**Planning, Land Use and Mobility Committee**  
**Case Report**  
**Lot Split and Flag Lot**

Case No: AA-2019-6661

Site Location: 23349-23555 Collins Street, 91367, between Woodlake Avenue and Manton Avenue

Project: The applicant is proposing to combine two side by side lots, and sub-divide resulting RA-1 zoned parcel into two lots thereby creating a flag lot in the rear. The applicant is also proposing to construct single family dwellings on both lots.

**Figure 4**  
**Preliminary Parcel Map for 23349-23355 Collins Street**

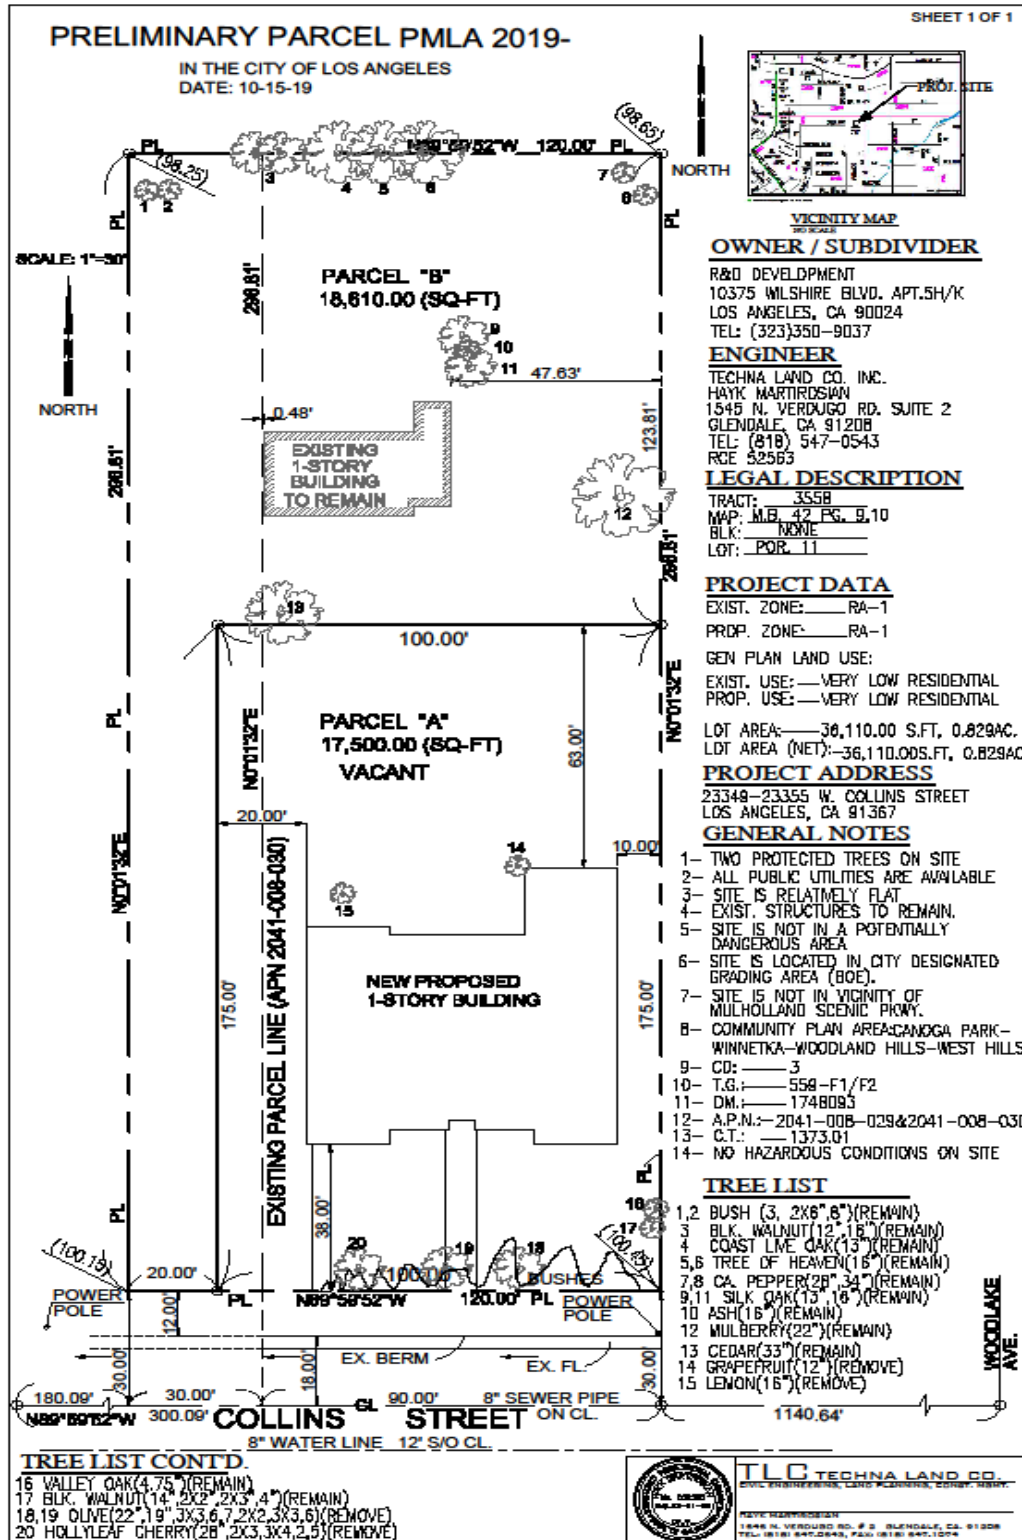
The lot split proposed by the applicant (**See Figure 4, attached**) results in two lots each conforming to the LAMC minimum area requirement of 17,500 sqft. for RA-1 zoned lots. **However, the rear lot does not conform to the minimum lot width requirement of 70 feet at the midpoint as defined by LAMC Article 2, Section 12.03 stated below.**

**Additionally, the Preliminary Parcel Map, dated 10/15/19, provided by the applicant does not include a provision for fire trucks to turn around at the rear end of the driveway to the proposed rear lot.**

WHEREAS, the Preliminary Parcel Map, dated 10/15/19, provided by the applicant includes a rear flag lot that does not conform to the lot width requirement of minimum 70 feet at the midpoint for RA-1 zoned parcels as defined by LAMC Article 2, Section 12.03; and,

WHEREAS, the Preliminary Parcel Map provided by the applicant, dated 10/15/19, does not include a feature for fire trucks to turn around at the rear end of the driveway to the proposed rear lot; and,
